Response to Submissions Report Lang Walker AO Medical Research Building - Macarthur

TERRY ROAD OR 100 PARKSIDE CRESCENT

Submitted to the Department of Planning, Industry and Environment
Prepared for Western Sydney University

Figure 3: Revised landscaping plan illustrating six bicycle parking racks on Parkside Crescent. Source: Turf

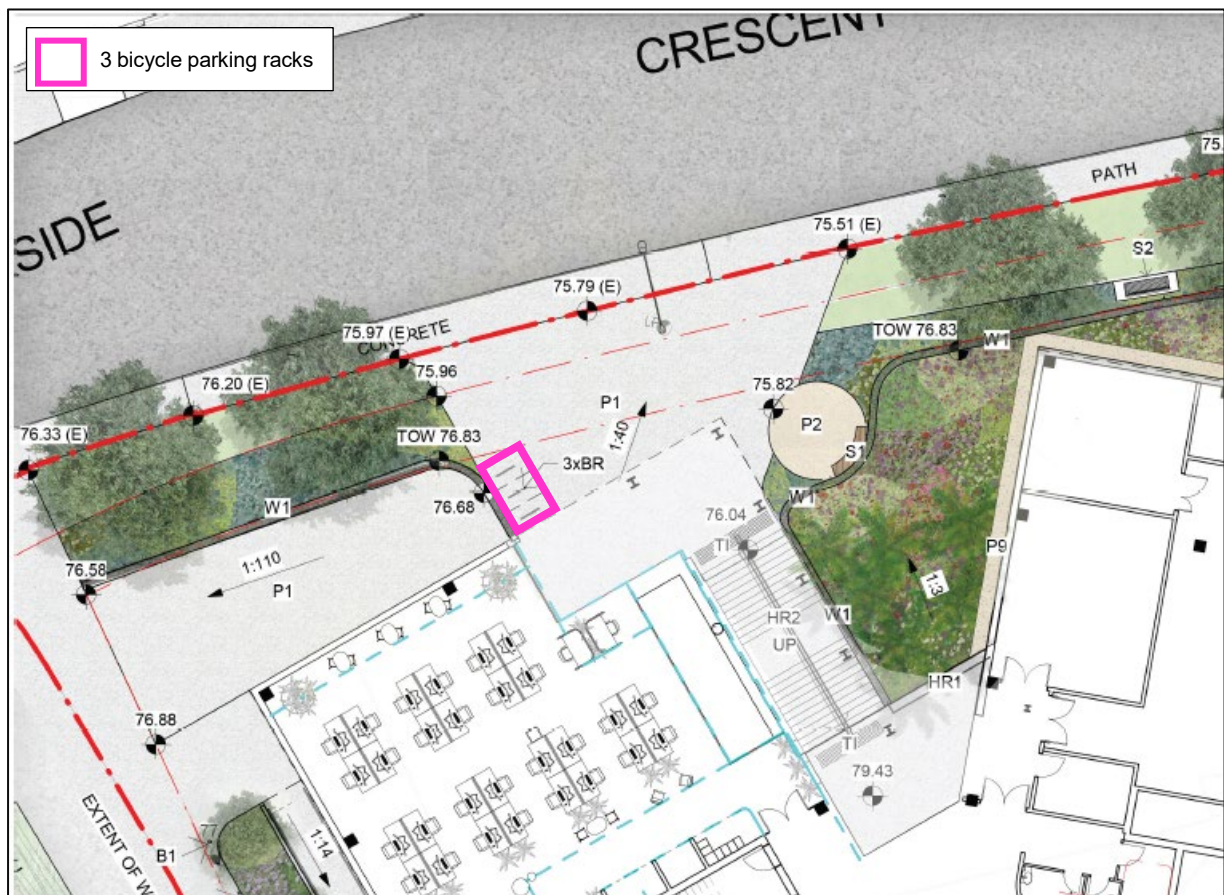
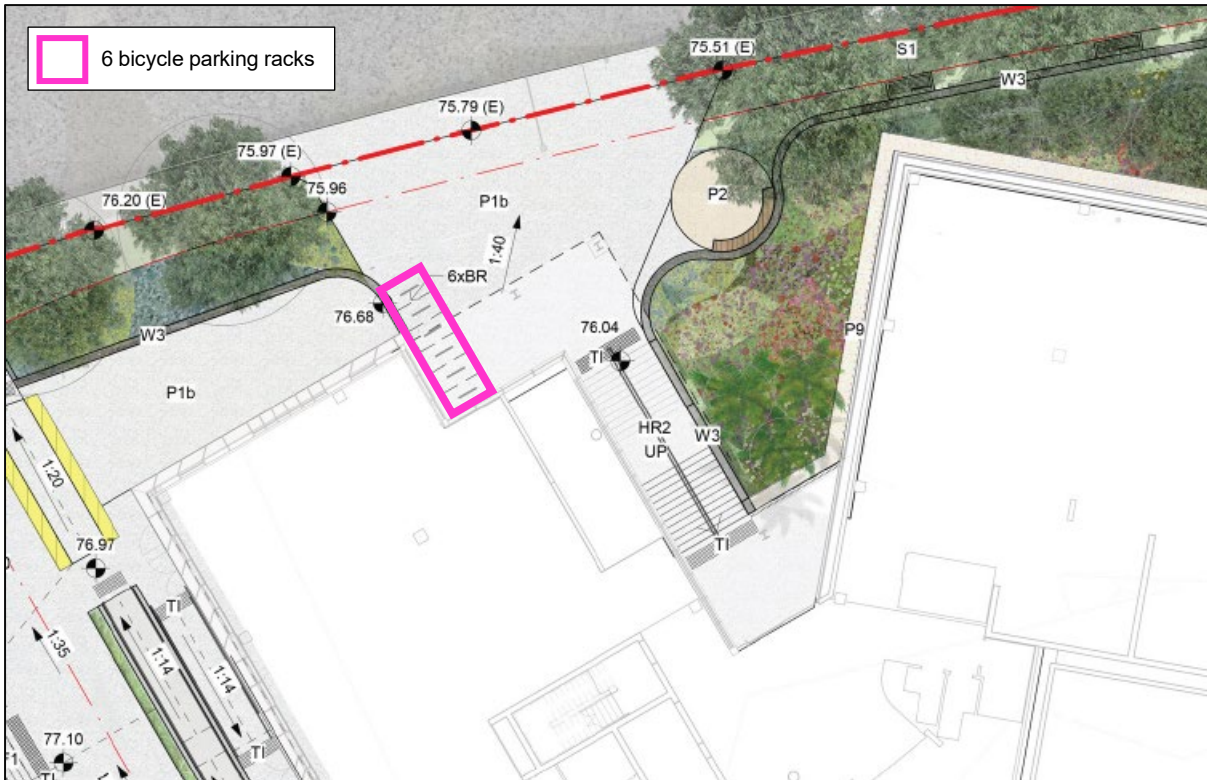
64. Feedback received from **DPIE** and **GANSW** indicated a preference for additional bicycle parking spaces to be included as part of the project.
65. In response, the project team have included an additional three bicycle parking racks on Parkside Crescent.
66. Each of the bicycle racks will be double stacked. Therefore, there will be a total of 12 bicycle parking spaces provided for the proposed health research facility.
67. **Figure 2** depicts the three bicycle parking racks as originally proposed. **Figure 3** depicts the six bicycle parking racks as now proposed.

Figure 5: Amended loading bay location. Source: BVN

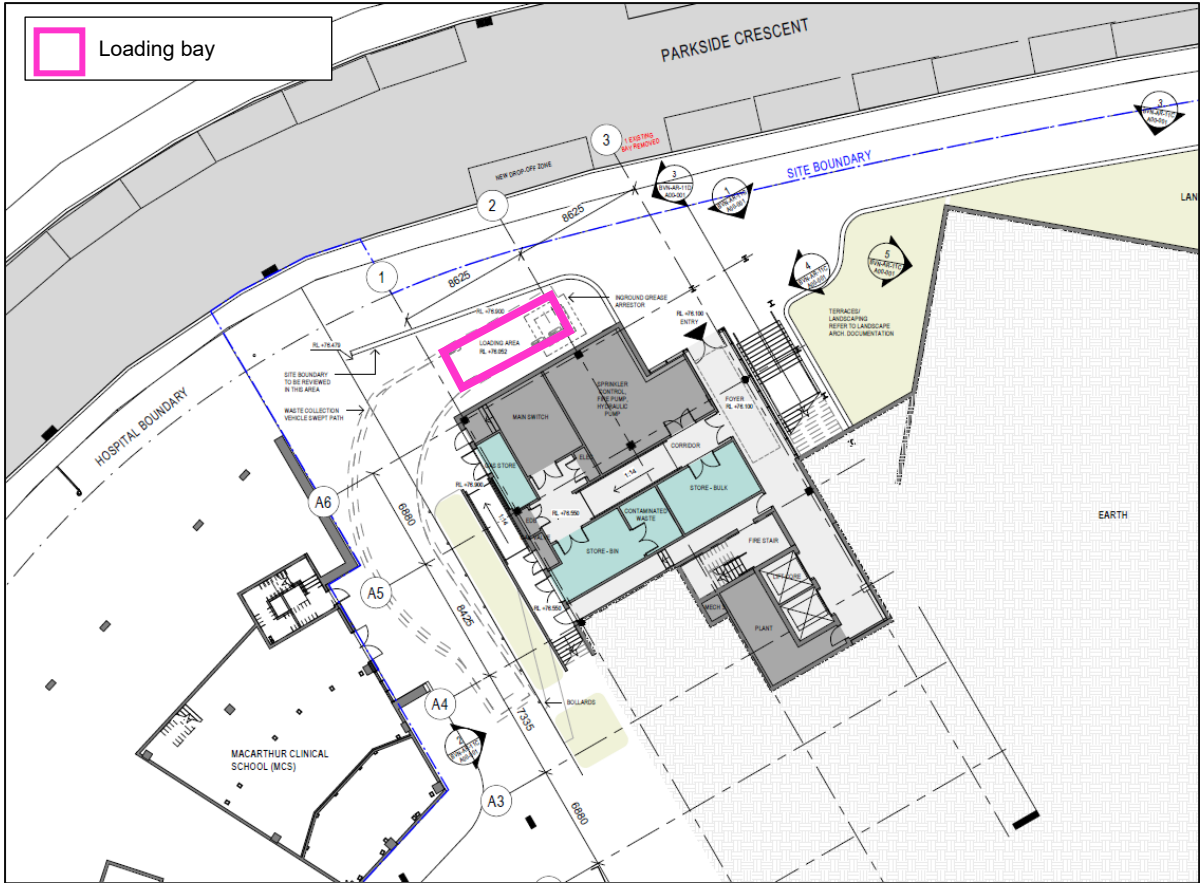
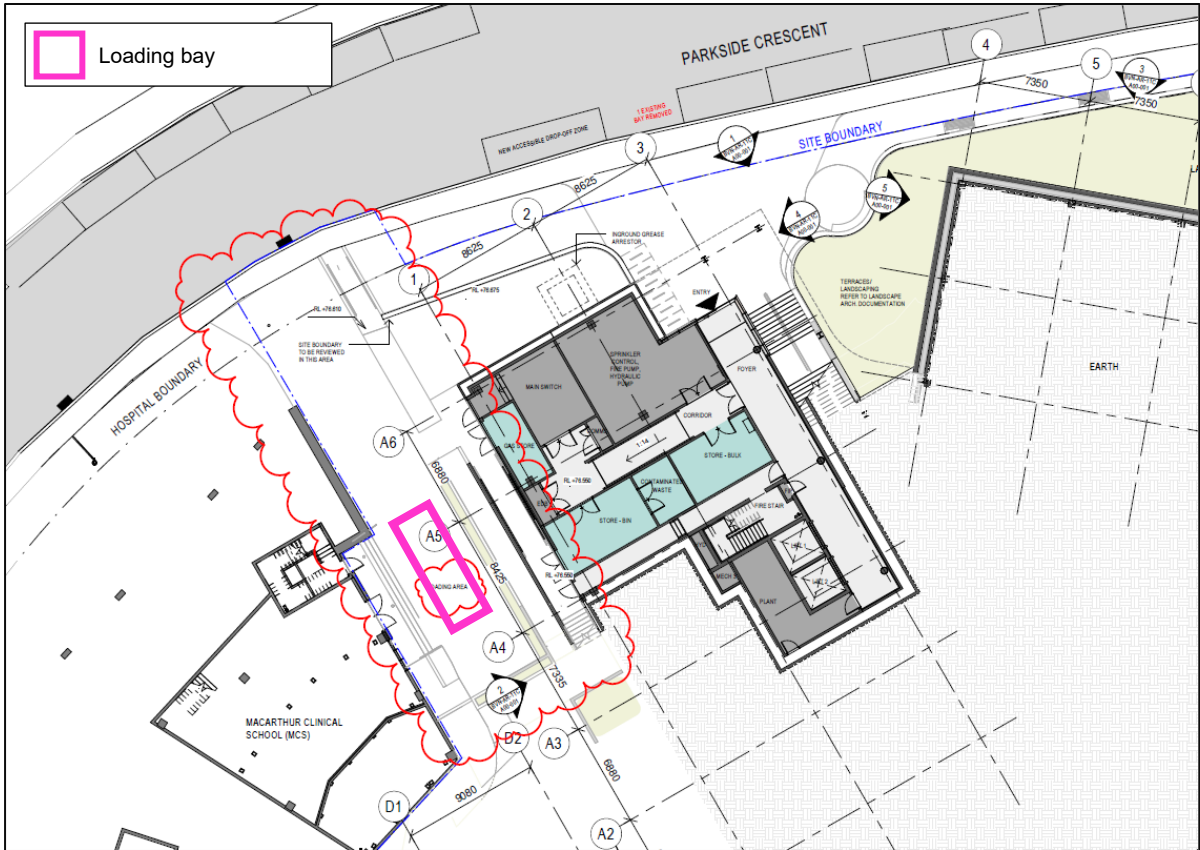
68. In their submission on the proposed health research facility, Council requested the loading bay be relocated so it would not be visible from Parkside Crescent.
69. In response, the project team have relocated the loading bay from the Parkside Crescent frontage to sit within the existing service bay between the proposed health research facility and existing MCS.
70. The hardstand area previously nominated as the loading bay is required to remain in order to facilitate the turning circle of waste management vehicles. Refer to **Section 1.1** of **Appendix C** for further detail.
71. **Figure 4** depicts the loading bay location as originally proposed. **Figure 5** depicts the revised loading bay location.

Figure 6: Landscape plan provided in the original submission. *Source: Turf*

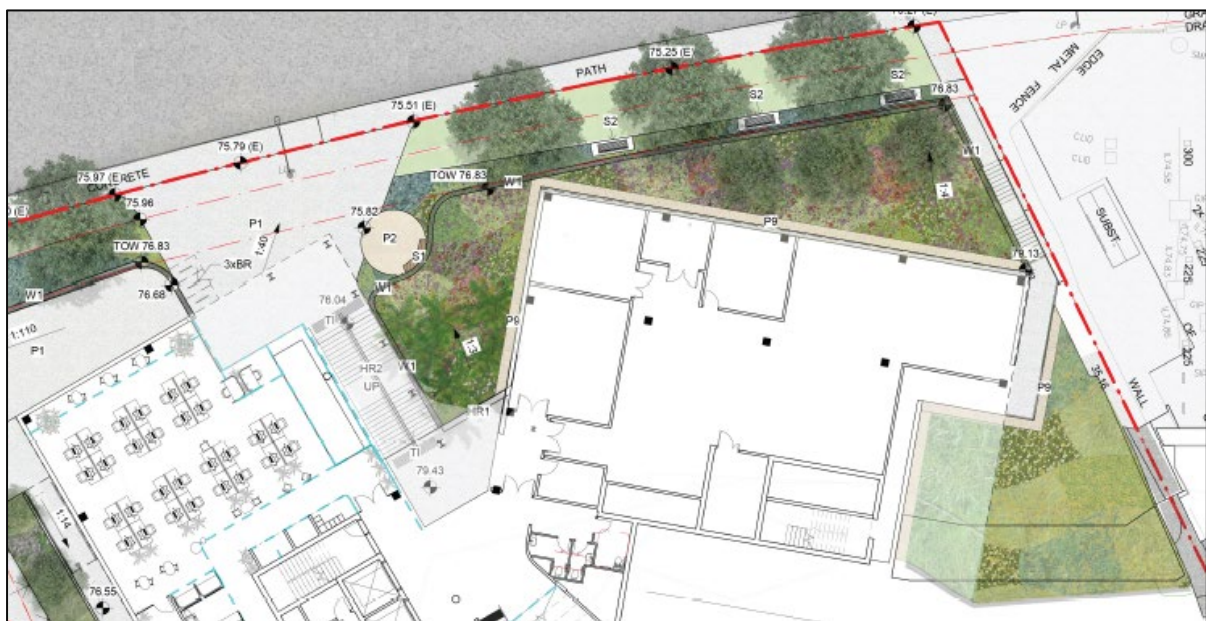
73. An amended Landscape Design Report has been included in **Appendix L** which includes the following amendments:
- The tree to the north of the proposed health research facility has been reinstated. **Figure 6** depicts the original ground floor planting design, and **Figure 7** illustrates the revised ground floor planting design with the tree reinstated.

- Street trees have been positioned on the Parkside Crescent frontage to provide shade over the waiting area. **Figure 6** illustrates the original street tree design and **Figure 7** illustrates the amended street tree design.

Figure 10: Accessible car parking location and walking distance. Source: BVN

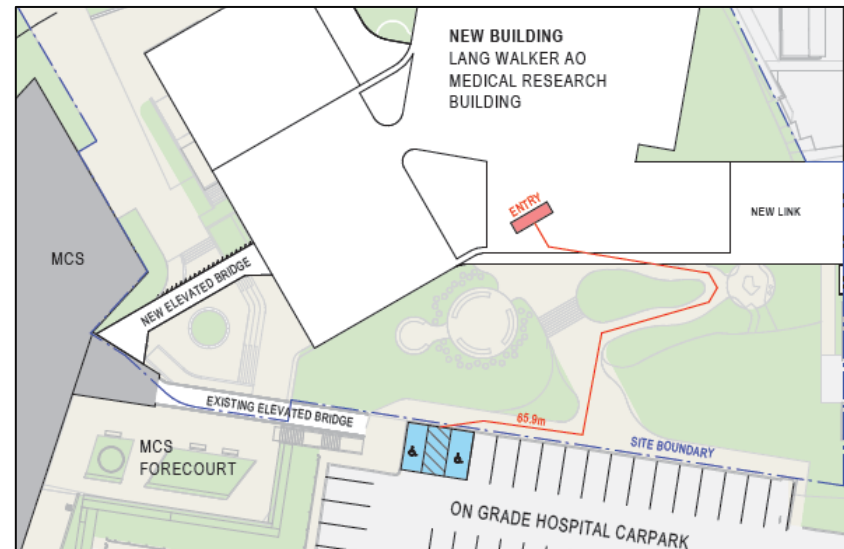
| Issue Raised | Project Team Response | |
|---|---|-------------------|
| <p>An indicative layout plan is to be submitted showing the location and walking distances to the research centre's assigned standard and mobility impaired parking spaces. In addition, access routes from mobility impaired spaces must also confirm that direct travel paths and suitable gradients are provided to future staff and visitors.</p> | <p>An indicative layout plan illustrating the location and walking distance to the proposed health research facility's standard parking spaces is located in Section 1.2 of the Architectural Response to Submissions report at Appendix C. An excerpt of the plan can be found in Figure 9 below.</p> | <p>✓</p> |

| Issue Raised | Project Team Response | |
|---|---|-------------------|
| | <p>Figure 9: Plan illustrating standard car parking spaces and walking distance. <i>Source: BVN</i></p> <p>An indicative layout plan illustrating the location and walking distance to the proposed health research facility's accessible parking spaces (i.e. mobility impaired parking area) is located at Section 1.2 of the Architectural Response to Submissions report at Appendix C. An excerpt of the plan can be found in Figure 10 below.</p> | <p>✓</p> |

Group DLA, the access consultant for the project, have reviewed the proposed accessible car parking spaces and confirm the spaces are capable of providing a reasonable and direct path of travel to the health research facility entry via the Village Green accessible pathways and stairs. Additionally, Group DLA confirm the design is capable of meeting relevant access standard provisions of AS 2890.6-2009.

Figure 13: Original and revised loading bay location. Source: BVN

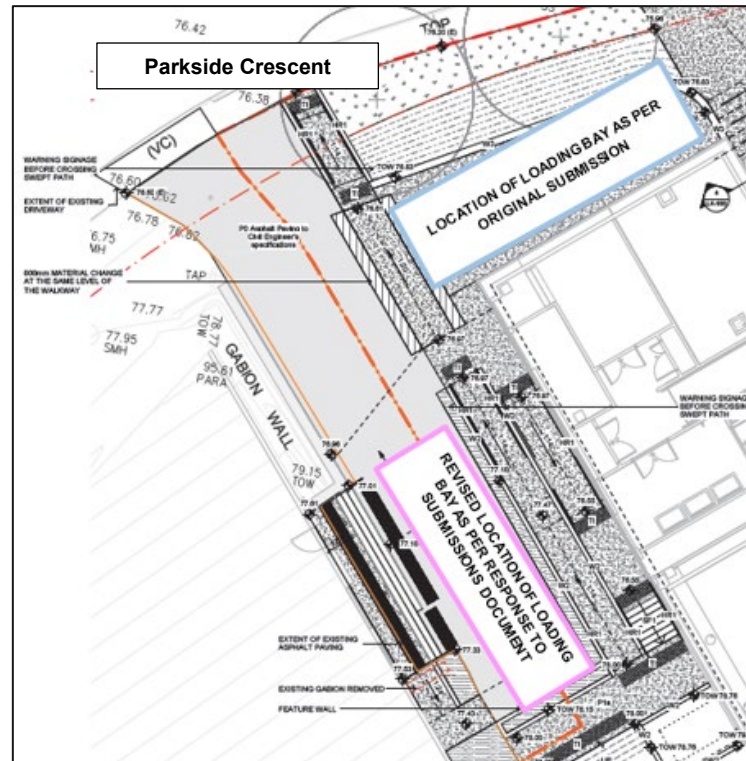
Similarly to the point above, Council is of the view that proposed loading area facing Parkside Crescent would not be the best location for loading from an aesthetic perspective. Council would appreciate if the loading area could be relocated so that it would not be visible from Parkside Crescent. The opportunity for the loading bay to be accessed from within the hospital site should be pursued, as this is a “back-of-house” activity that should not be located between the building and the street.

In response to Council’s request for the loading dock location to be revised, the project team propose for the loading bay be relocated from the Parkside Crescent frontage to the service road between the proposed health research facility and the MCS. Refer to **Figure 13**.

Figure 15: Existing overland flow path at southern site boundary. Source: TTW

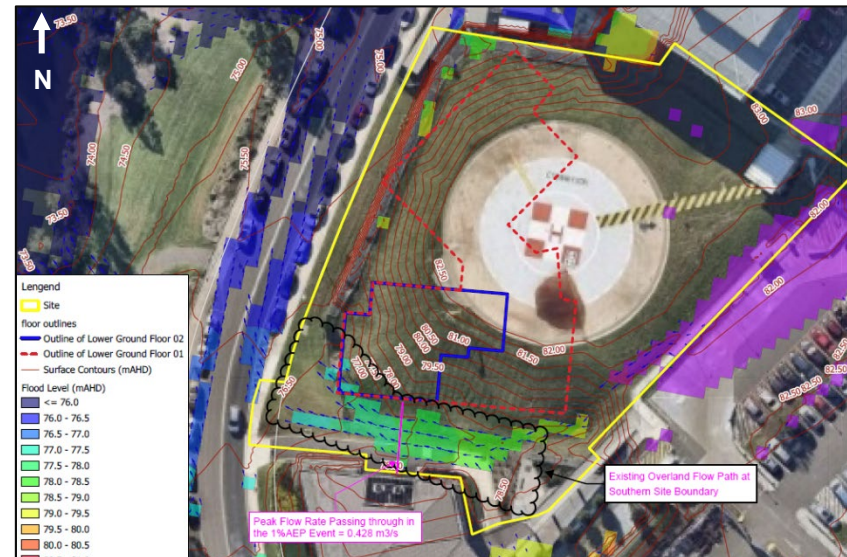
The site is impacted by overland flow from the car park at the hospital. Council discussed this matter with the proponent’s engineers previously, and it was indicated that an overland flow path to the north of the proposed building would be included in the design. This flow path is not evident on the plans, however it is needed and should collect the overland flow and manage its discharge to the pipe drainage system in Parkside Crescent. Overland flows over the footpath, or discharge to the road surface are not permissible.

TTW were engaged by the project team as the civil engineer for the project. TTW have reviewed the issued raised by Council have confirm the proposed health research facility does not have any adverse impact on the existing flood levels or overland flow paths outside the project area, including Parkside Crescent and the footpath.

The existing overland flow path for the upstream catchment (including the existing car park east of the site) is along the southern site boundary which drains onto Parkside Crescent (**Figure 15**).

Figure 17: Left: Flood levels and depths (1% AEP) – Proposed conditions (ground floor).
Source: TTW Right: Flood levels and depths (PMF) – Proposed conditions (ground floor).
Source: TTW

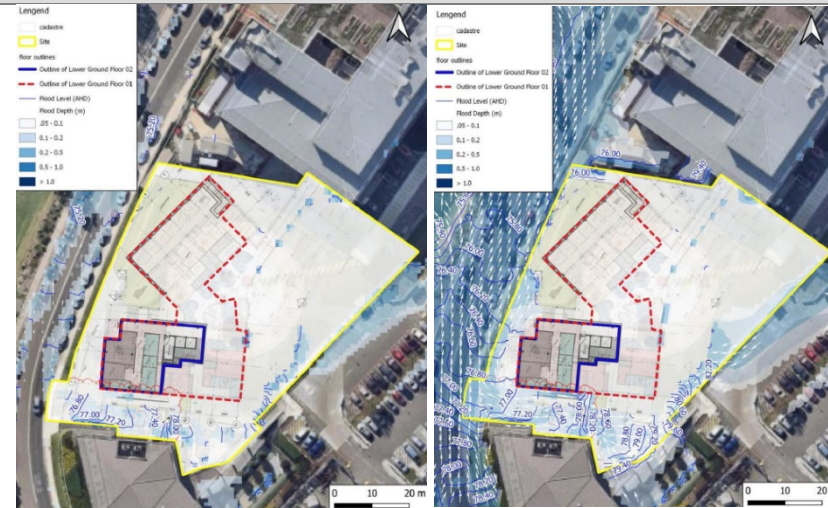
| Issue Raised | Project Team Response | ✓ |
|---|--|-------------------------|
| <p>EES has concerns regarding the flood model accuracy. The proposed conditions flood mapping shows flooding inside the building footprint, most notably in Figure 19 of the Civil SSDA – Flood Assessment and Stormwater Management Report Lang Walker AO Medical Research Building – Macarthur (the flood report). The building should be blocked out in the model and no flooding should be present within the building footprint. If the building is not blocked out, impacts will not be properly assessed.</p> | <p>In response to EES feedback, TTW, in their capacity as civil engineer for the project, have updated the Civil SSDA – Flood Assessment and Stormwater Management Report (Appendix O) to illustrate the proposed health research facility blocked out in the images.</p> <p>TTW have advised no flooding is present across the proposed building footprint (Figure 17).</p> | <p>✓</p> |

TTW, the civil engineer for the project, has updated the Civil SSDA – Flood Assessment and Stormwater Management Report to provide clarification with regards to floor levels and associated flood levels. Please refer to **Response to EES Comments** and **Section 6.0 of Appendix O** for further detail.

TTW have advised all proposed floor levels are above the design flood planning levels for the 1% AEP storm event plus 300mm freeboard. This is compliant with Council's flood planning requirements in the Campbelltown Sustainable City Development Control Plan 2015 (DCP).

Figure 19: Flood impact assessment map (PMF event). *Source: TTW*

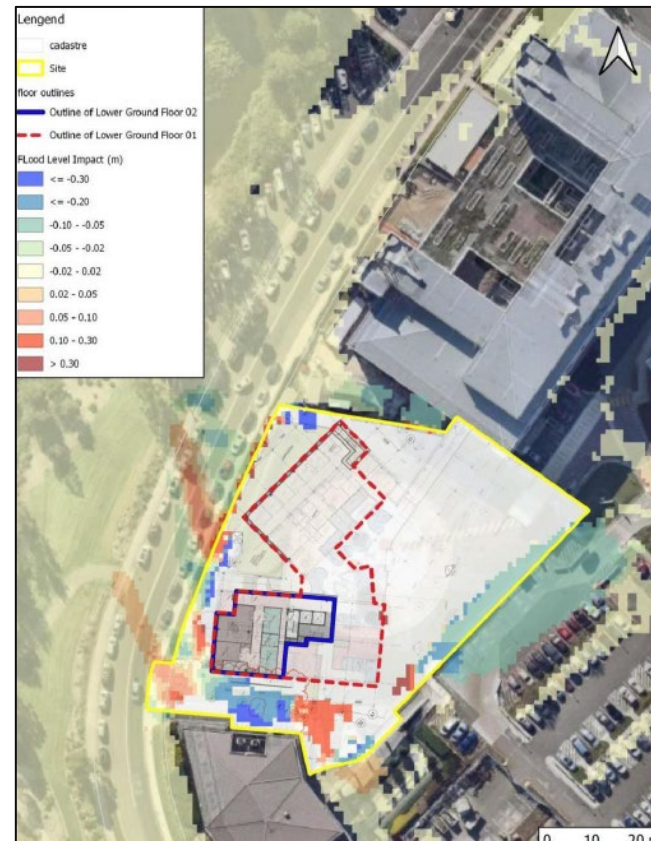
Further detail is required on flood impacts. The Flood Impact Assessment Map for the 1% AEP flood event does not allow assessment of significant impacts because a band of -20 mm to +20 mm has been used. No significant impact is typically considered to be within -10 to +10 mm. The mapping should be revised accordingly. Further, due to the potentially sensitive nature of adjacent land uses (hospital buildings), impact assessment is also required for the PMF event and a corresponding map should be provided.

TTW have prepared a flood impact assessment map for the PMF (Figure 19).

TTW have advised the proposed health research facility does not have any detrimental effect on adjacent buildings during the PMF event.
